FAR NORTH DISTRICT COUNCIL
Private Bag 752
KAIKOHE
Ph: 0800 920029
Fax: (09) 401 0987 or (09) 408 1404

NAME: B. Erwin	DATE:	PIM/BC No: 970172	
VALUATION No:	LEGAL DESC:		
BUILDING: New Dwelling	LOCATION:

RE: BUILDING CONSENT APPLICATION 970172 - NEW DWELLING

STRUCTURAL CALCULATIONS FOR PROPOSED NEW DWELLING

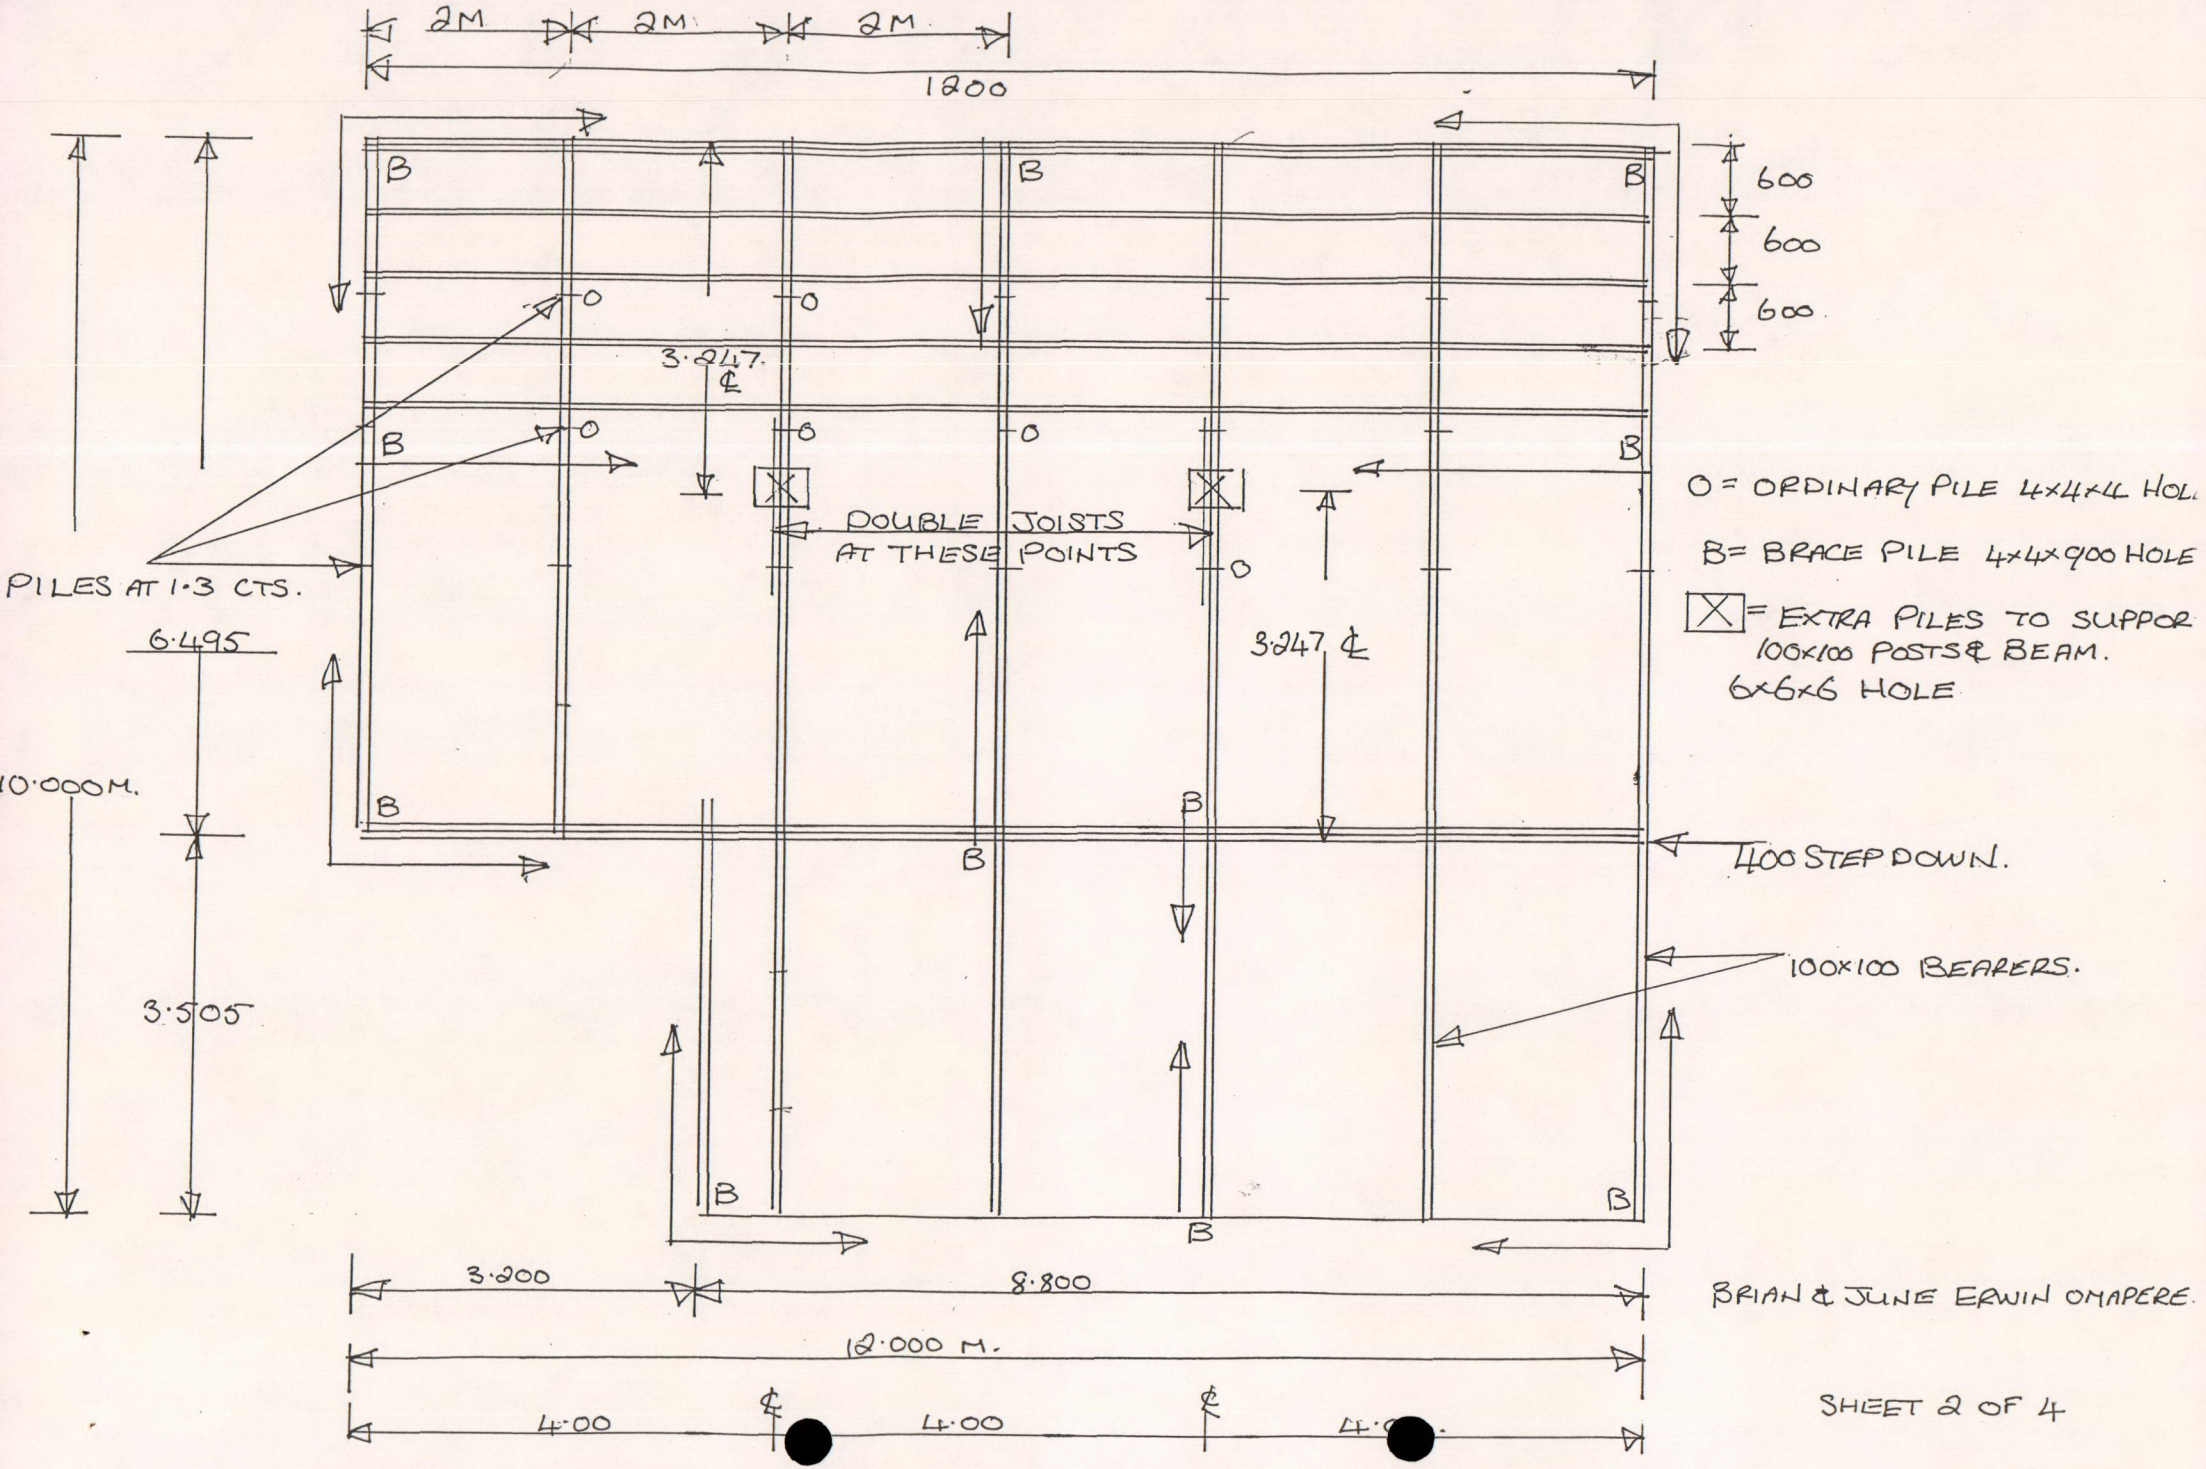
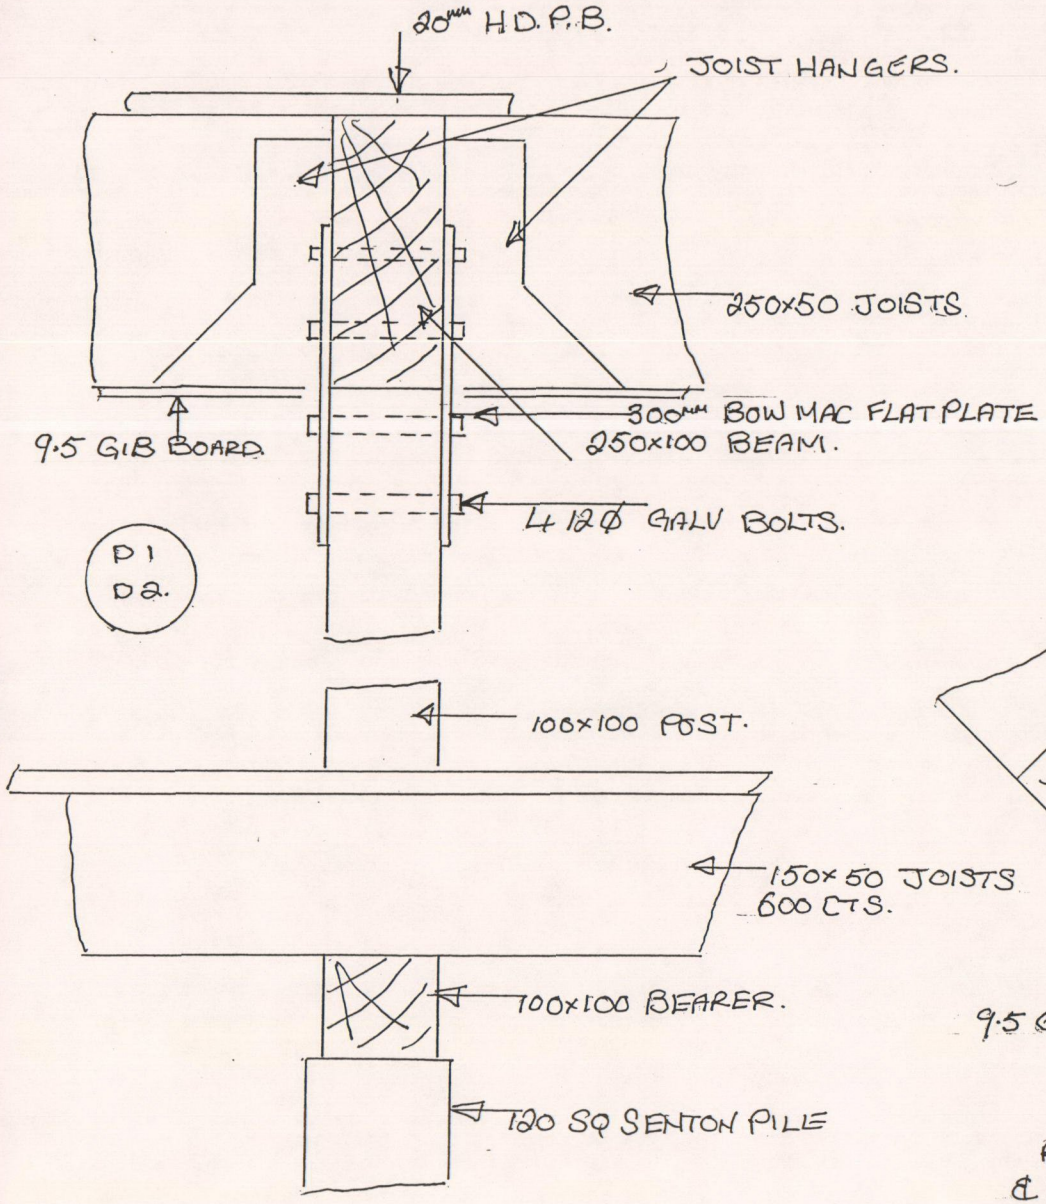
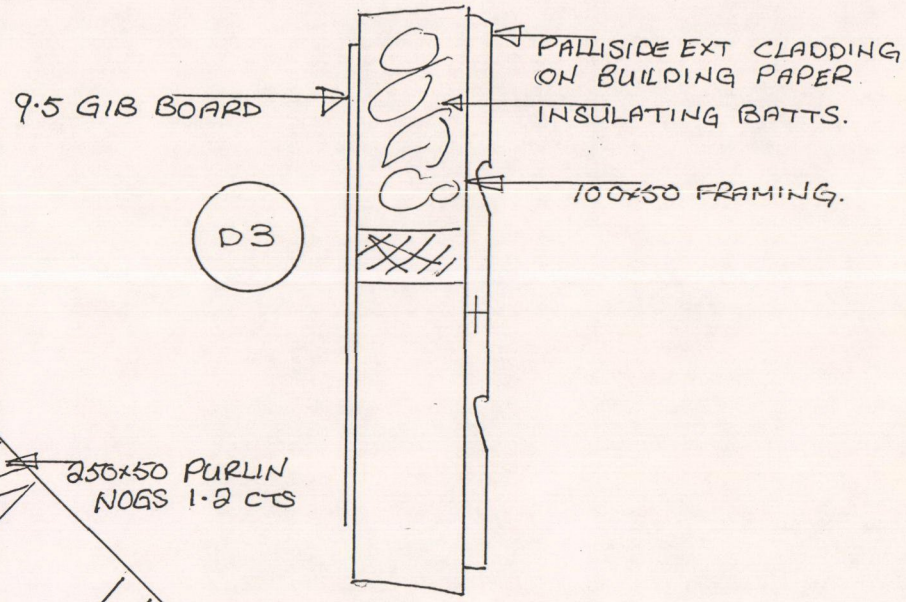
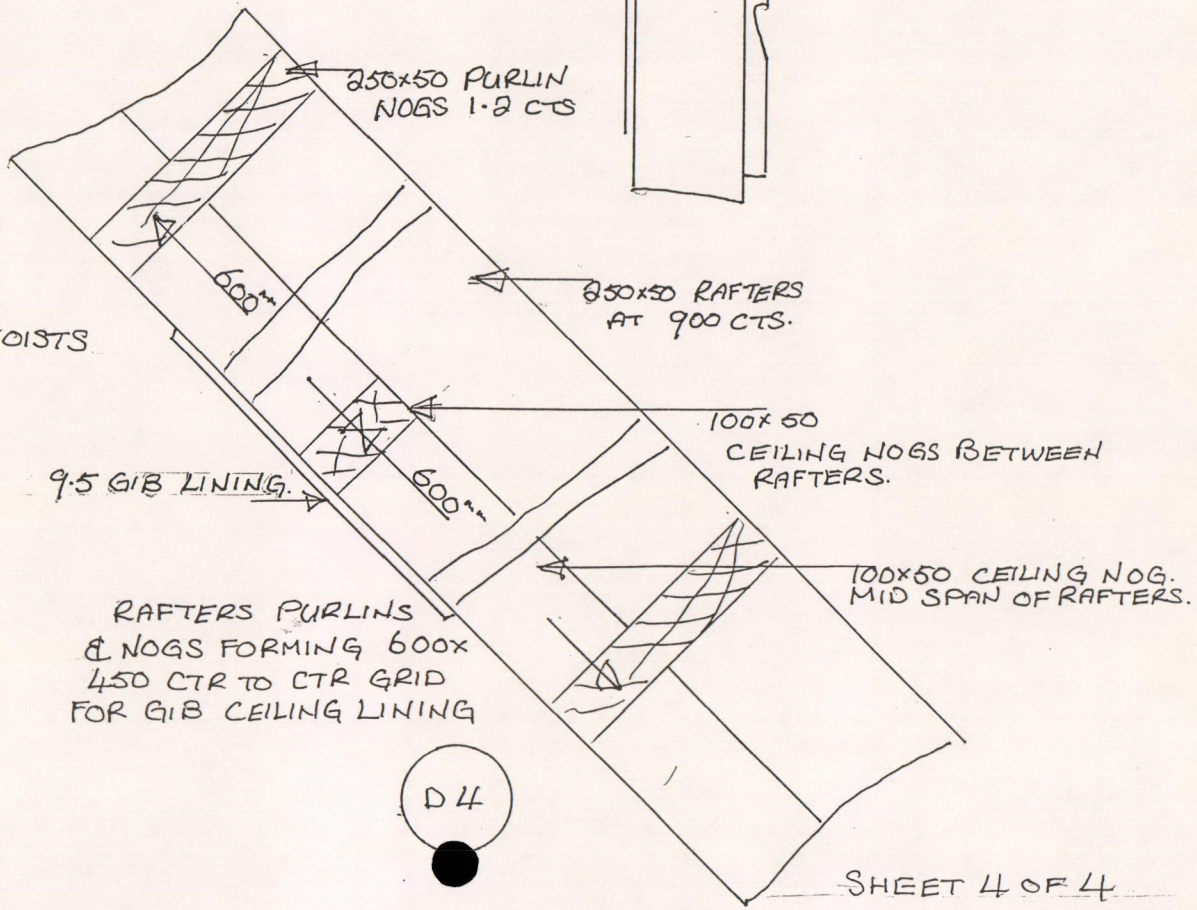
1 Please provide elevations of proposed new dwelling

4 Please provide plans showing all doors, windows, ventilation and layout of all rooms.

5 Please note that building must have a continuous foundation.

Exceeds critical standard for ~~height in relation to boundary~~ sunlight - non-complying 3m ~~to~~ plus the shortest horizontal distance from boundary. Chapter 5.8.4.5.4

~~Ver~~ 5.8.4.3.6 (b) requires all buildings to provide a verandah met.

Provide details of anticipated excavation.
